## Little Falls Parkway Vision Zero Safety Improvements Environmental Assessment

**LITTLE FALLS PARKWAY  
Vision Zero Environmental  
Assessment**

**June 18, 2024**

Figure 8: Crashes Between Arlington and Hillandale 2015

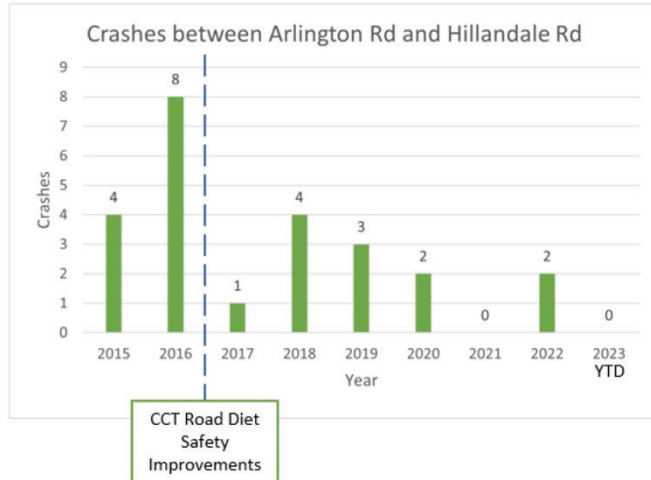
3. The road diet put into effect in 2017, following the death of a bicyclist at the CCT crossing, was very effective in reducing crashes, from a maximum of 8 in 2016 steadily declining to zero in 2021. There is no evidence that the Phase 2 changes – the current configuration, begun in mid-2022 – have added significantly to safety there. This chart was part of Parks

submission to the County Council on November 1, 2023. Parks plans to restore the median here – a good move – but this does not entirely remove the potential for conflict between bicyclists/pedestrians/cars. This is an opportunity to review other ways to improve safety, including perhaps by reconsidering rerouting the CCT to the traffic signal at LFP and Arlington.

Comments are wide ranging and  
addressed throughout the draft EA
